State of New Mexico
Energy, Minerals and Natural Resources

WELL API NO. 30-025-07371
5. Indicate Type of Lease STATE [] FEE [x]
6. State Oil & Gas Lease No. 19520
7. Lease Name or Unit Agreement Name North Hobbs G/SA Unit
8. Well Number 341
9. OGRID Number 157984
10. Pool name or Wildcat HOBBS; GRAYBURG-SAN ANDRES
11. Elevation (Show whether DR, RKB, RT, GR, etc.) 3634' (Gr)

Objective: Plug & abandon wellbore

Action 555606

Proposed WBD

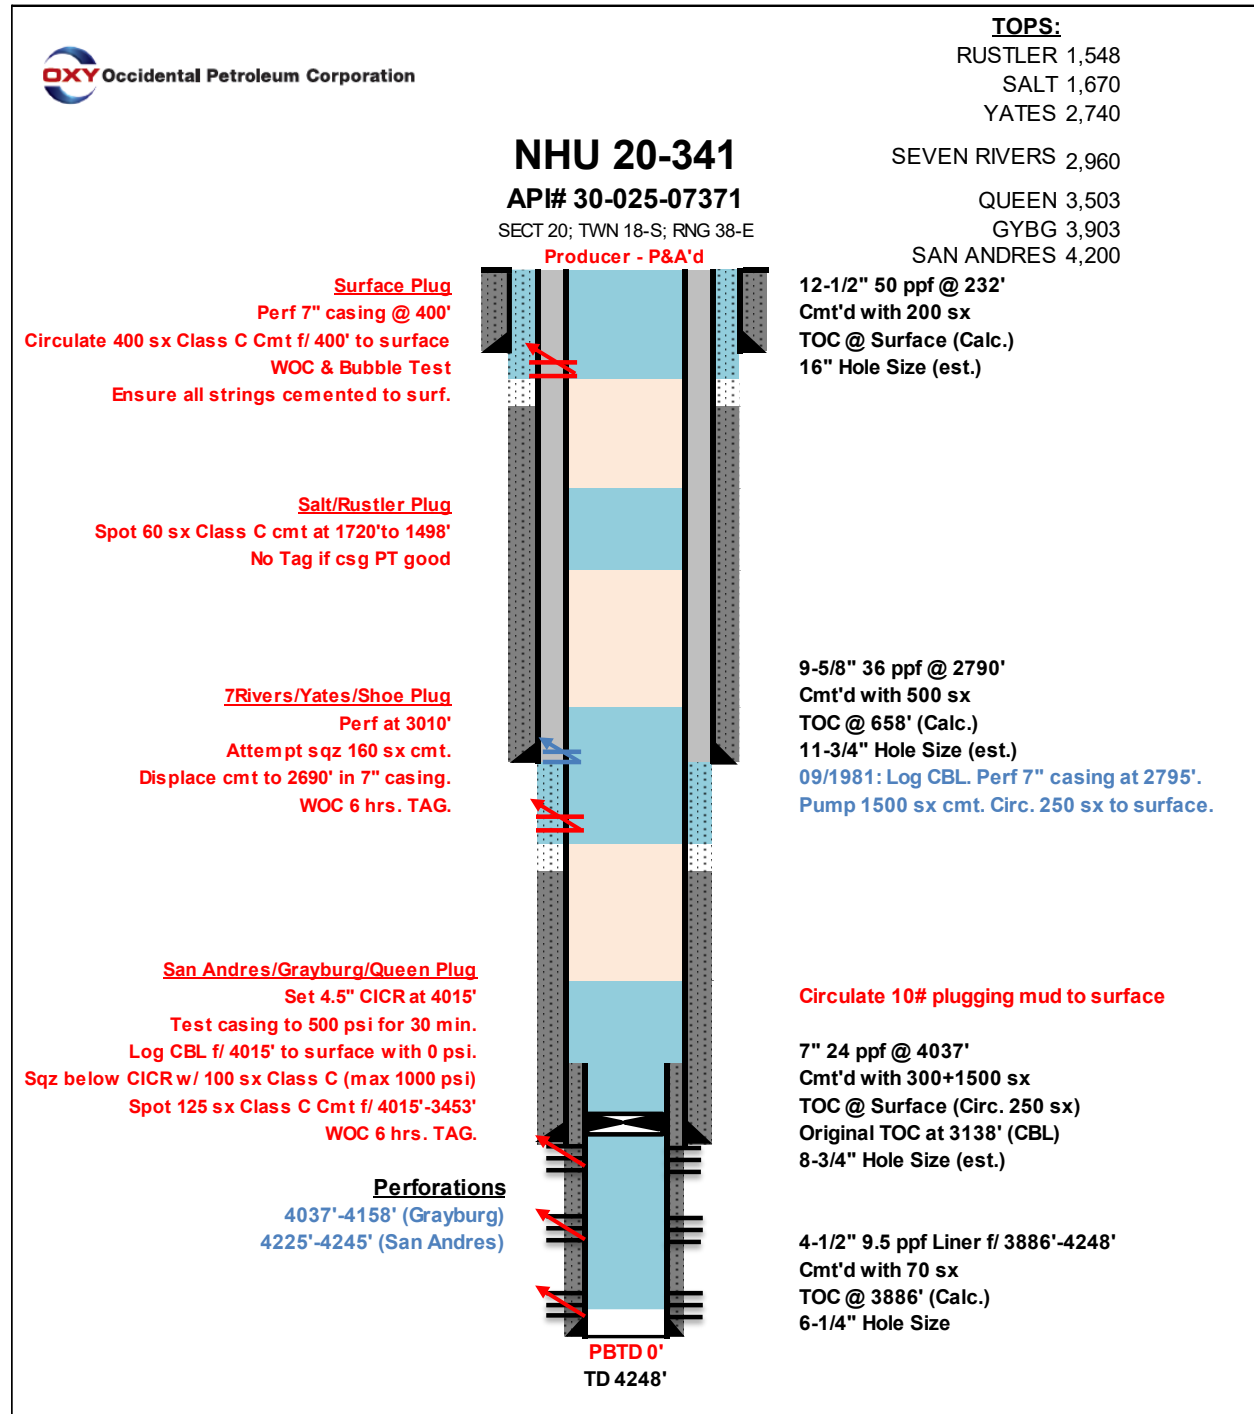
1. MIRU.
2. POOH & LD rods, pump & 2-7/8" production tubing.
3. RU WL. Set CICR at 4015'.
4. Pressure test casing to 500 psi for 30 min.
5. Log CBL f/ 4015', **Keep fluid in hole & run CBL to Surface with zero psi.**

6. **Run Casing Inspection Log to surface.** - RD WL.
7. PU workstring x RIH & tag CICR @ 4015'.
8. Establish injection rate below CICR. Squeeze 100 sx Class C cmt below retainer to max 1000 psi
(San Andres/Shoe plug)

9. WOC 6 hrs. Report to NMOCD.
10. Tag CICR at 4015'. Spot 125 sx Class C cmt f/ 4015' to 3453' or greater **(GB/Queen plug)**.
11. WOC 6 hrs & Tag TOC. Report to NMOCD.

12. Circulate hole w/ 10# plugging mud.
13. Perforate 7" casing @ 3010' (verify w/ CBL). Attempt squeeze 160 sx Class C cmt. Displace cement to 2690' **(Seven Rivers/Yates/Shoe plug)**.

14. WOC 6 hrs & Tag TOC. **Bubble Test** - Report to NMOCD.
15. Spot 60 sx Class C cmt f/ 1720' to 1498' or greater **(Salt/Rustler plug)**.
 - a. No tag required if casing pressured good from Step (4) & CBL confirms good cement behind 7" casing.

16. Perforate 7" casing @ 400'. Circulate 400 sx Class C cmt from 400' to surface. **(Surface plug)**
17. Ensure cement is to surface on all casing strings. **WOC & Bubble Test**
